2.2 Control and Instrument Systems

The information in this section of the reference ABWR DCD, including all subsections, tables, and figures, is incorporated by reference with the following departures.

Figure 2.2.1 Rod Control and Information System Control Interface Diagram

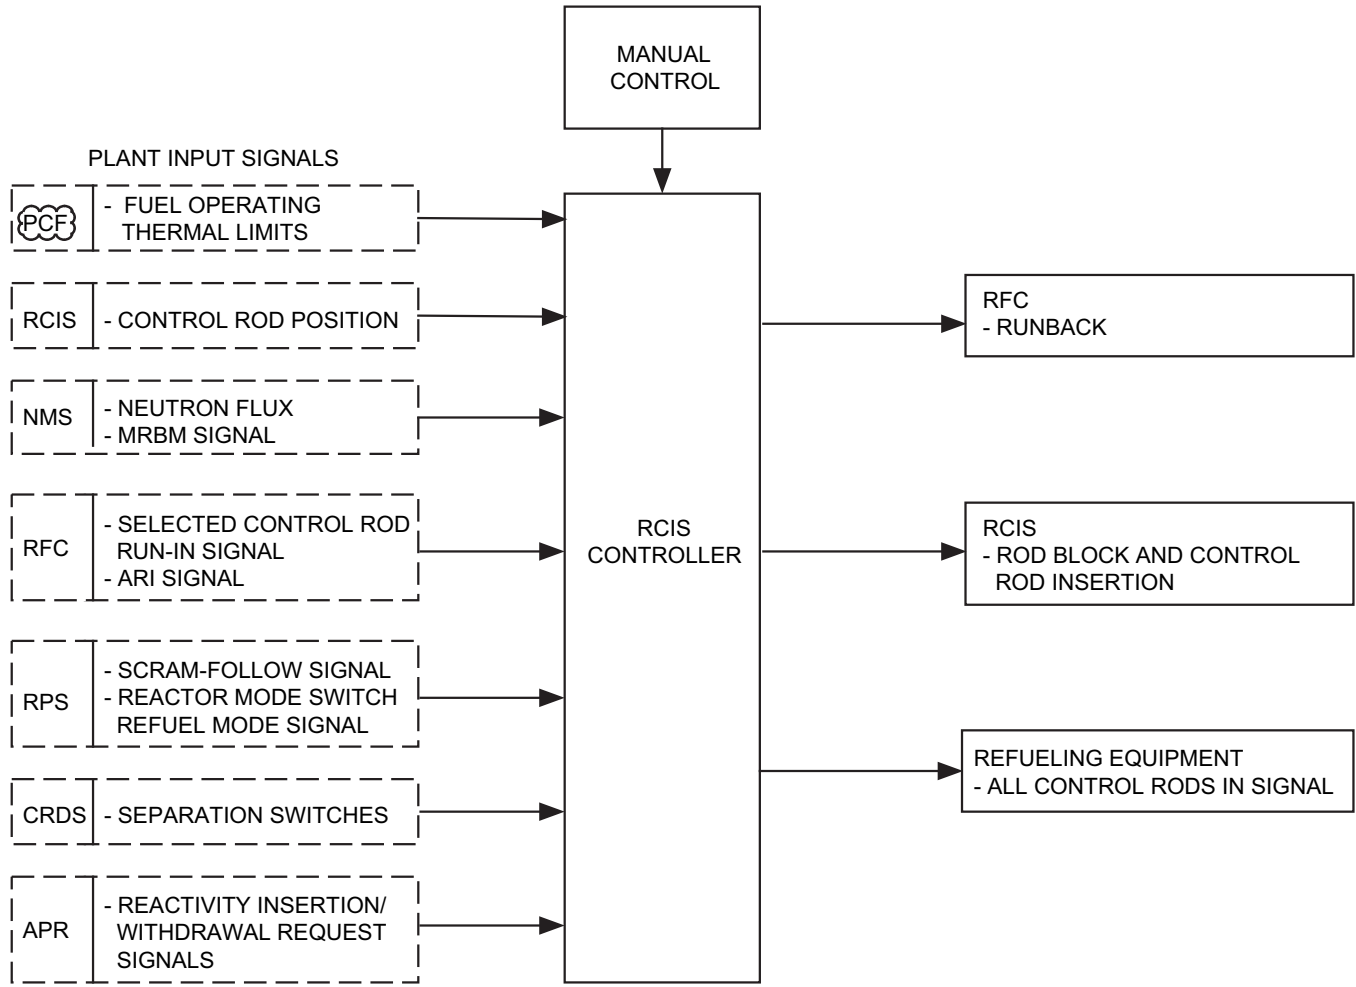
STD DEP T1 3.4-1 (Figure 2.2.1)

NOTE:
1. INTERCONNECTIONS MAY BE FIBER-OPTIC OR METALLIC.

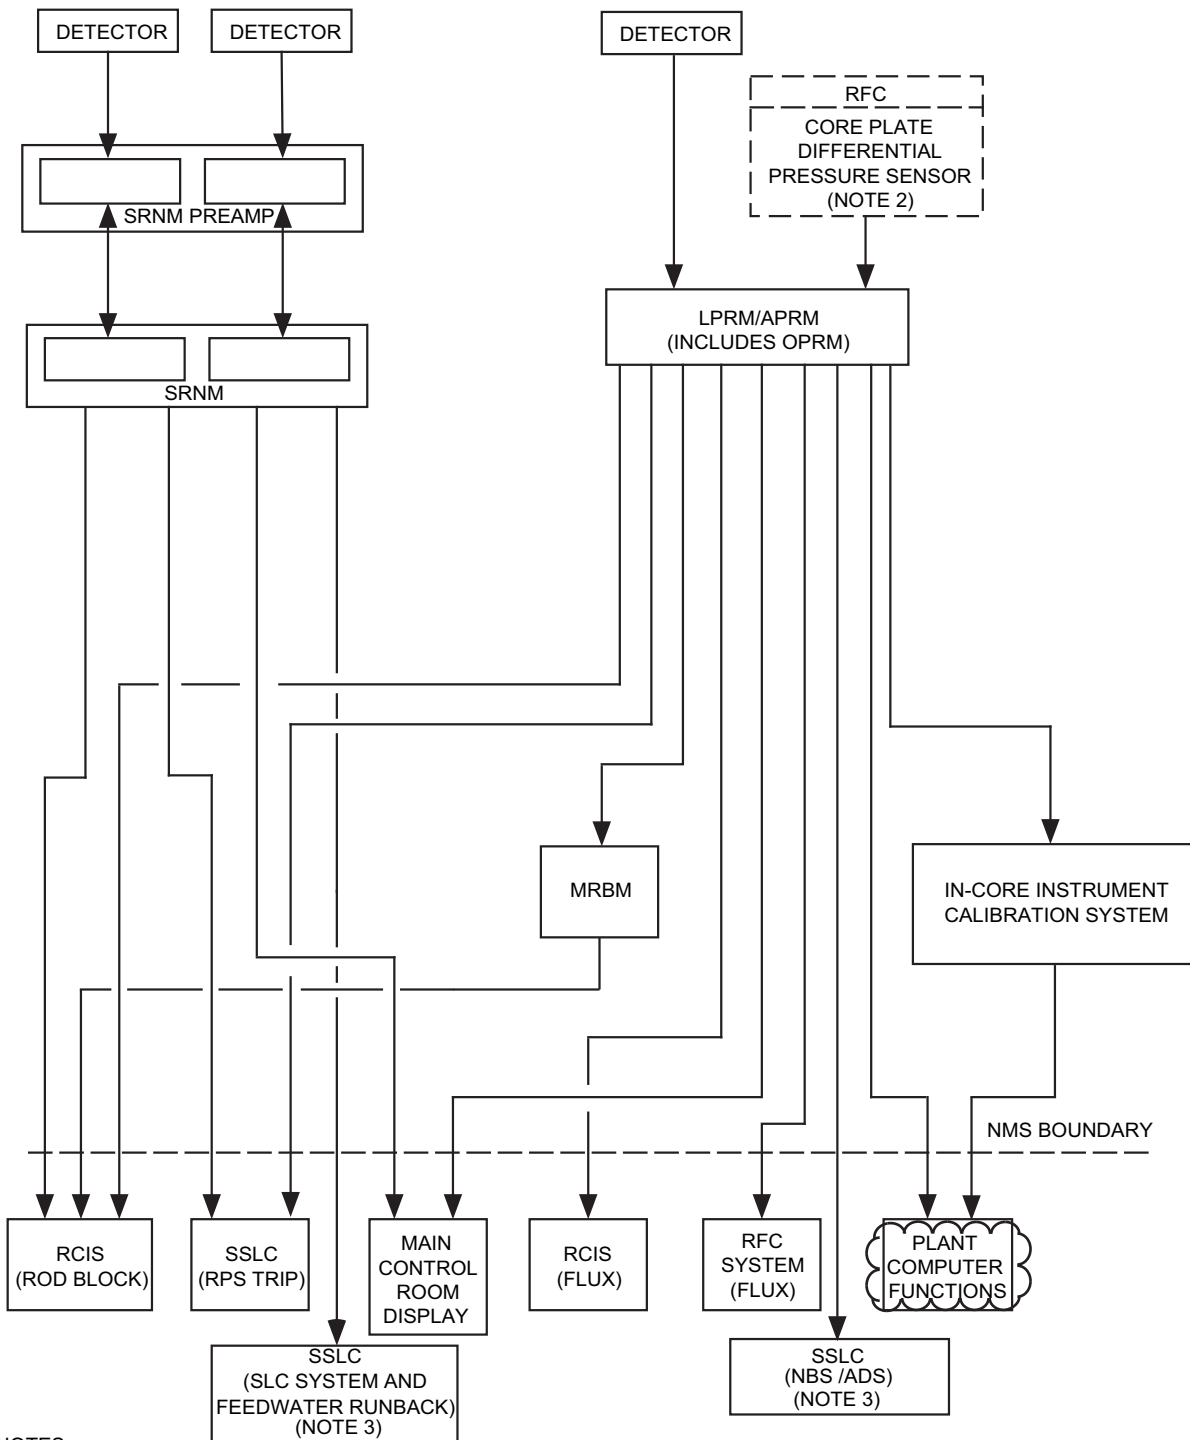
The FDWC digital controllers determine narrow range level signal using three reactor level measurement inputs from the NBS. ~~Sensor signals are transmitted to the FDWC digital controllers by the Non-Essential Multiplexing System (NEMS).~~

The steam flow in each of four main steamlines is sensed at the RPV nozzle venturis. ~~Sensor signals are transmitted to the FDWC System digital controllers by the NEMS.~~ These measurements are processed in the digital controllers to calculate the total steam flow out of the vessel.

Feedwater flow is sensed at a flow element in each of the two feedwater lines. ~~Sensor signals are transmitted to the FDWC digital controllers by the NEMS.~~ These measurements are processed in the digital controllers to calculate the total feedwater flow into the vessel.

Figure 2.2.7b Reactor Protection System

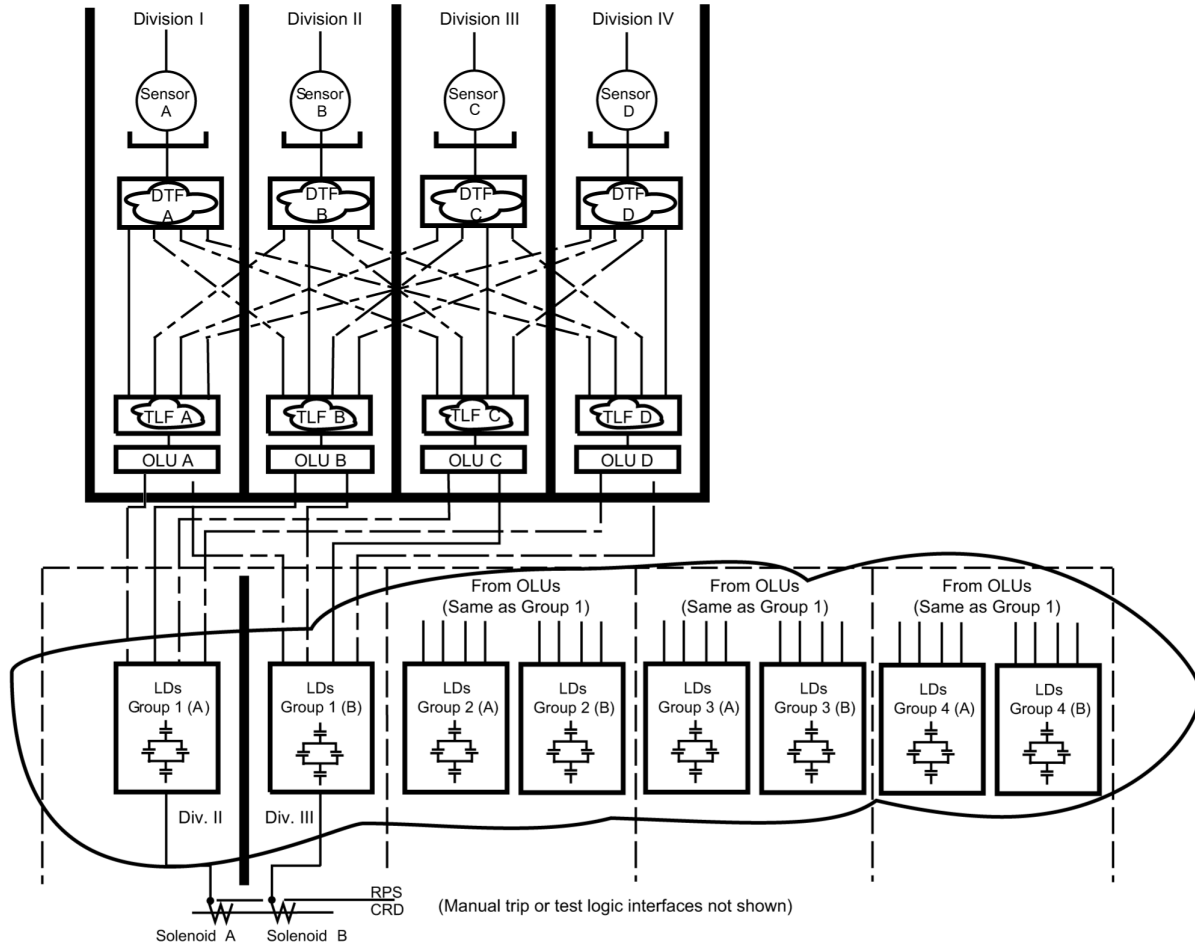
STD DEP T1 3.4-1 (Figure 2.2.7b)

The RPS has four divisions. Figure ~~2.2.6a~~ 2.2.7b shows the RPS divisional aspects and the signal flow paths from sensors to scram pilot valve solenoids. Functions Equipment within an RPS division consists of include sensors (transducers or switches), I/O, ~~multiplexers~~, data communication, digital trip modules functions (DTM DTF), trip logic unit function (TLU TLF), output logic unit (OLU), and load drivers (LD). The LDs are only in Divisions II and III. The (DTF) and (TLF) are performed in digital configurable logic devices. The data communication functions are described in Section 2.7.5.

The RPS consists of logic and circuitry for initiation of both automatic and manual scrams. The automatic scram function is ~~comprised of~~ accomplished redundantly in four independent divisions of sensor instrument channels, hardware/software based logic and logic processing, and two independent divisions of actuating devices. Automatic scram is initiated whenever a scram condition is detected by two or more automatic divisions of RPS logic. ~~For automatic scram, the sensor input signals to the RPS originate either from the RPS's own sensors or other systems' sensors. For determination of the existence of an automatic scram condition, within each automatic scram channel division of the RPS, the DTM DTF of a given RPS channel division compares the monitored process variable with the a stored setpoint stored in its memory and issues a trip signal if the monitored process variable exceeds the setpoint. The DTM DTF then sends the trip signal to the TLU TLF of its own channel division and the TLU TLFs of the other three channels divisions of RPS, where two-out-of-four voting is performed (see Figure 2.2.6a). The TLF in each division performs an independent two-out-of-four vote on each RPS DTF input.~~

The ~~TLU~~ TLEs provide their trip signals to their divisional OLUs which ~~are used to~~ control the solid-state LDs that control the Class 1E AC power to the scram solenoids, and relays that control DC power to back-up scram valves. For automatic scram initiation, the ~~TLU~~ TLE trip signals cause the LDs to interrupt Class 1E AC power to the scram solenoids (fail-safe logic), cause the back-up scram relays to supply DC power to back-up scram solenoids, and provide scram follow signals to the RCIS. Each division of RPS controls eight LDs. The LDs are arranged to switch AC power to the scram solenoids in a two-out-of-four ~~format arrangement~~. That is, reactor scram will occur only if two or more divisions of the RPS provide trip signals to their associated LDs and both scram solenoids are de-energized.
